# TURNOVER STUDY

**KEG File: 19RS-0128**  
**July 9, 2019**

*Watercrest Community  
Association, Inc.  
19360 Nearpoint Drive  
Venice, FL 34292*

**RE: Watercrest Community Association, Inc.  
KEG Project No. 19RS-0128  
Professional Engineering Services – Association Turnover Report**

**Photo 9- pool deco drain**

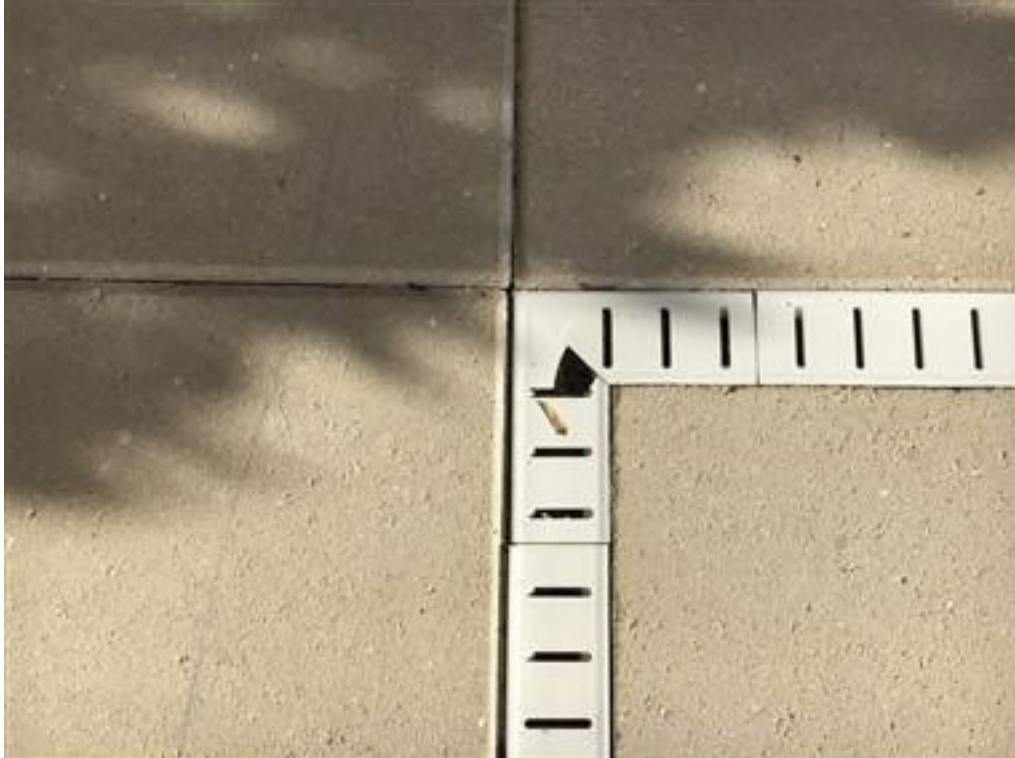
**Deco Drain;** the deco drain at the pool area has open joints and broken areas that should be addressed before they become a hazard and liability to the Owners.  
Photos 8, 9, 10, 11

**Photo 14- pool pavers**

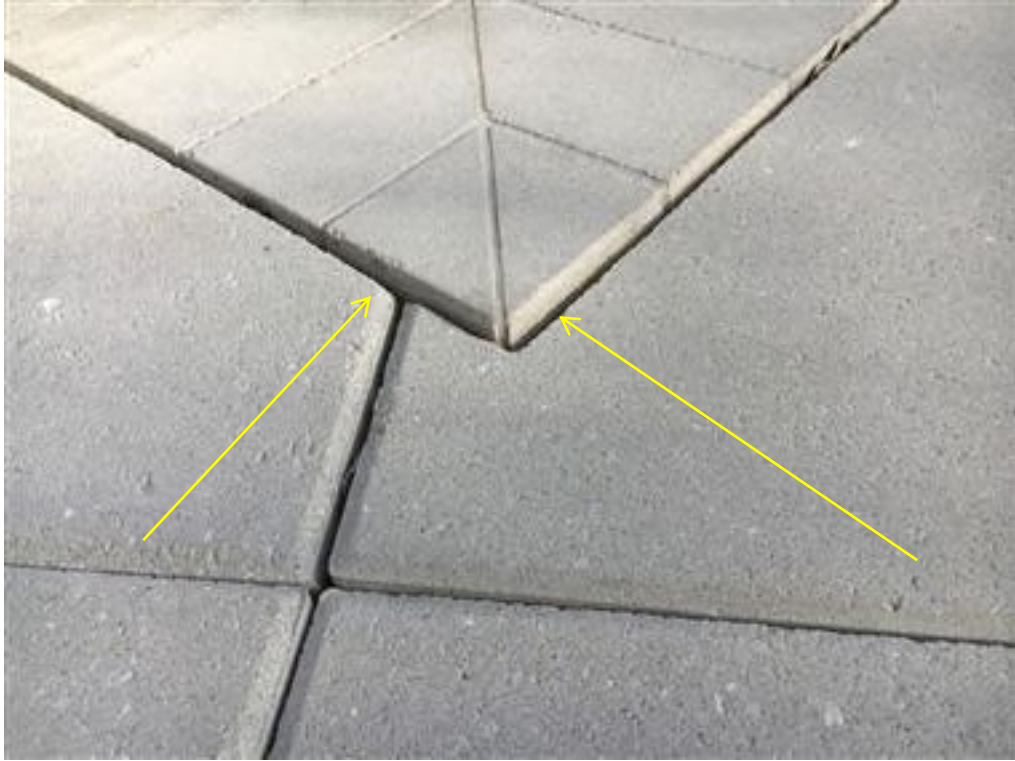
**1. Hazards; Trip Hazard At Pool Paver And At The Entrance Pavers**

*Commentary:* pavers, tile, and any uneven walk surfaces should be installed to minimize level changes resulting in trip hazards, including the pool areas.

**Photo 99- wall cracks**

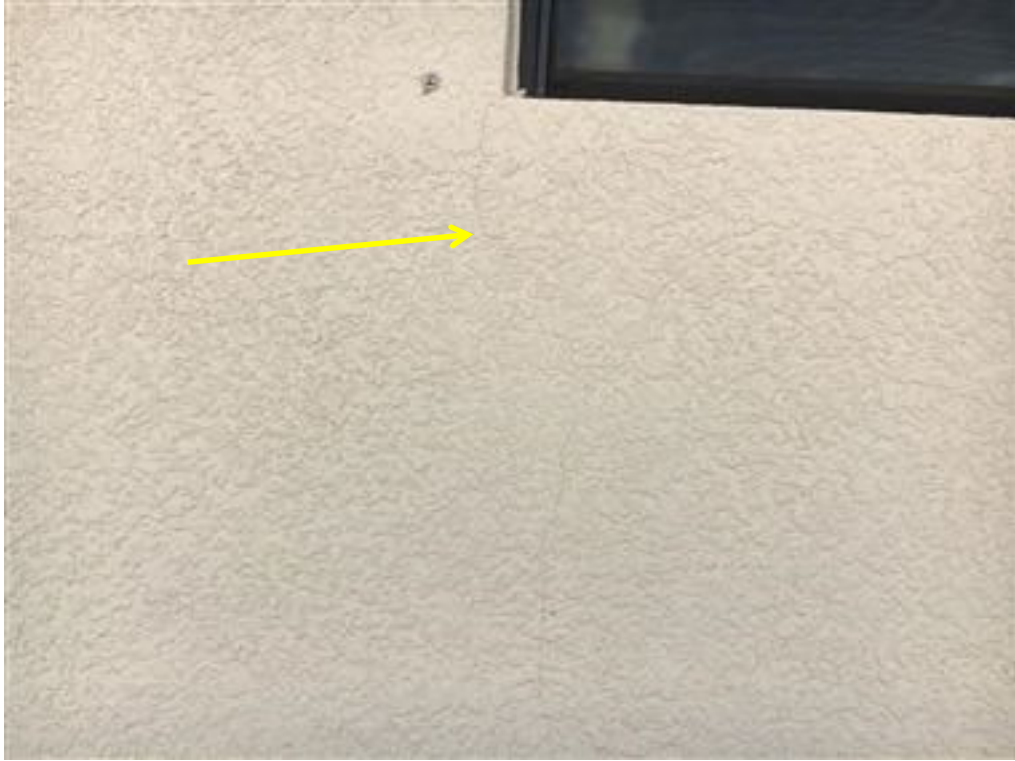
**3. Coatings (paint); Hairline Cracks At Building Exterior Walls**

*Commentary*; The conditions of the observed coatings indicate it is near the end of its useful expected life. A repaint Project should be scheduled accordingly. All exterior finishes shall be applied in accordance with the manufacturer's specifications or installation instructions.

**Photo 102- open trim joint 9832 Haze Drive**

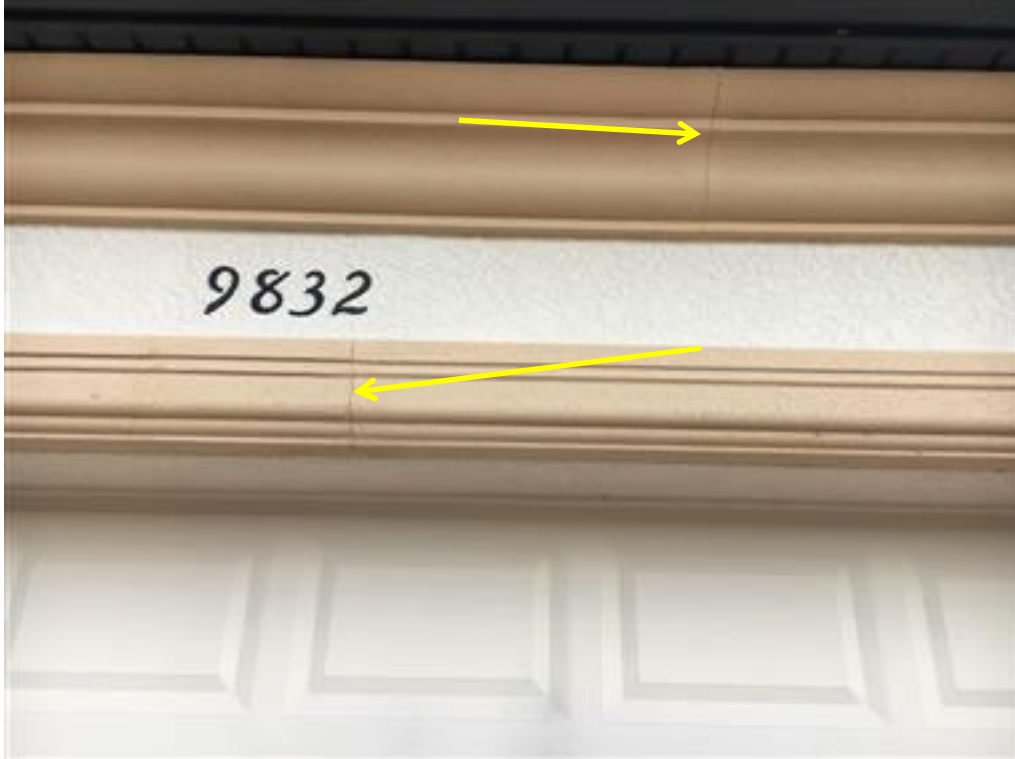
**2. Sealants (Caulk), Missing, Improper Application At Window And Door Perimeters**

*Commentary:* The improper sealant joint configurations do not comply with the referenced design considerations to prevent entry of water. The industry standard for application of sealants requires that the sealant material be no less than ¼” thick at each surface. This would provide a minimum ½” face width on all caulk/sealant joints. In addition, an area of separation (to receive the sealant) between the perimeters and the stucco or trim is required. Window and door frames exhibit minimal or improper sealant application at their perimeters. This will allow water intrusion into the structure and building interior.
